Access Compliance Report

Public Rights-of-Way

(Curb Ramps)

Intersection ID: N/A	Main Street: TRYON_ST	Cross Street: NEVADA_BV	Location: E
ADA ID: 69C94F021A7D	Ramp Type: PerpDiag	Initial Pass/Fail: Fail	Overall Compliance: No
		Severity Score: 22.5

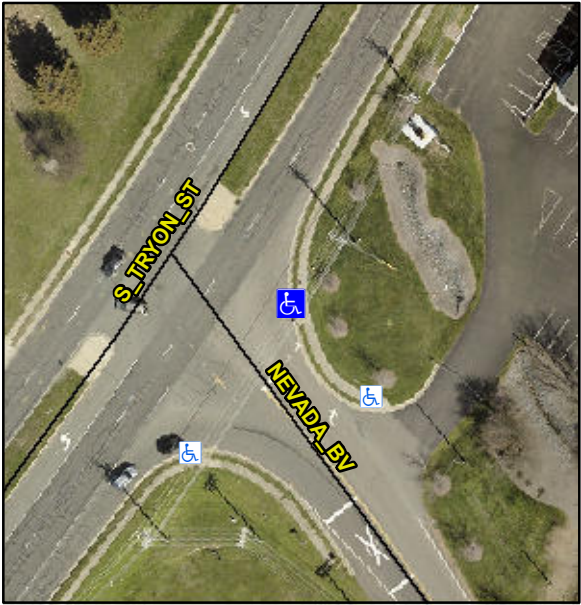
Codes/Mitigation Info/Possible Solution			Field Measurements/Component Compliance		
	Possible Solutions:		Compliance	Description	Data
	Remove & Replace Curb Ramp With Two New Directional Ramps or Equivalent.		No	Ramp Length (in)	48.0
			No	Ramp Width (in)	47.0
			N/A	Flare Type LT	N/A
			N/A	Flare Slope LT (%)	N/A
			N/A	Flare Traversable LT?	N/A
			N/A	Landing Length (in)	N/A
			N/A	Landing Width (in)	N/A
			N/A	Landing Slope (%)	N/A
			N/A	Landing X Slope (%)	N/A
			N/A	Landing Curb? (Y/N)	N/A
			N/A	Shared Landing?	N/A
			N/A	Gutter Ponding?	N/A
			N/A	Gutter Lip Ht (in)	N/A
			No	Painted X Walk1?	N/A
				X Walk 1 Direction	To N
			N/A	X Walk 1 Width (in)	N/A
				X Walk 1 Slope (%)	0.7
				X Walk 1 X Slope (%)	2.8
			N/A	Ramp inside XWalk1?	N/A
<p>Surveyor Notes:</p> <p>N/A</p> <p>PROW/ADA:</p> <p>R304.5.1, R304.2.2, R304.5.3</p>			N/A	Flare Type RT	N/A
			N/A	Flare Slope RT (%)	N/A
			N/A	Flare Traversable RT?	N/A
